HERITAGE PRESERVATION COMMISSION REPORT

Certificate of Appropriateness- Downtown Commercial Historic District.

PROPOSAL: The applicant is proposing to install a deck on the rear façade of the building located at 327 Jay Street.

Proposed Plan

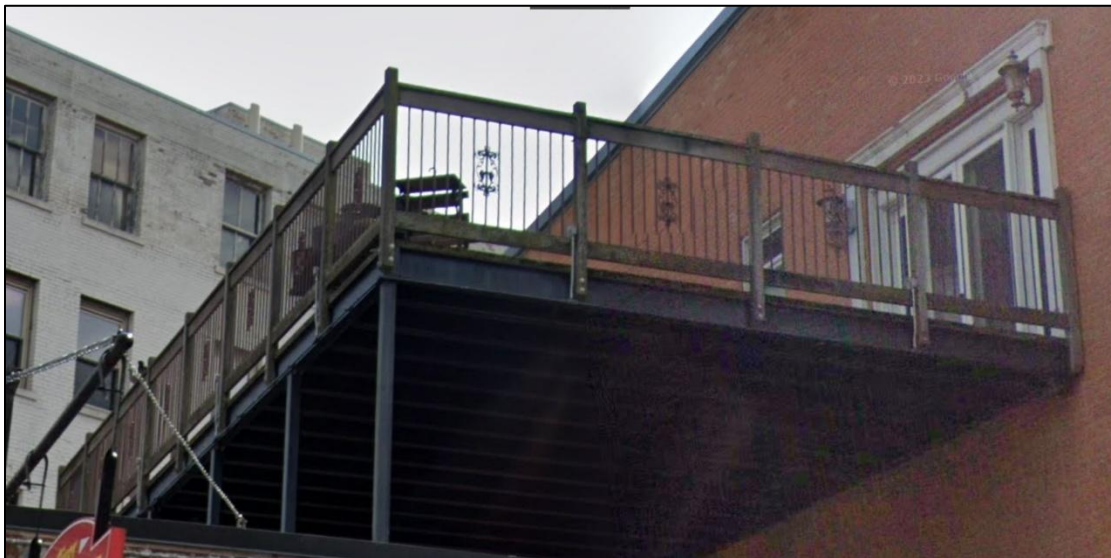
FINDING: The proposed deck is at the rear of the building where there is typically more flexibility in design and use of materials. However, due to its location and high use of the adjacent alley, it will be highly visible, even from Jay Street. The design standards for the district are not particularly clear when reviewing these types of projects so staff looked at other decks that were added. All of them have a mix of visible wood and ornamental metal, especially as part of the railings. This design element was proposed to the applicant, but they chose to submit it as is. The proposed design is, in staff's opinion, not consistent with other decks and materials but the design standards are not crystal clear on this.

RECOMMENDED ACTION BY STAFF: This Certificate of Appropriateness is recommended for approval with the condition some ornamental metal is worked into the design of the railing.
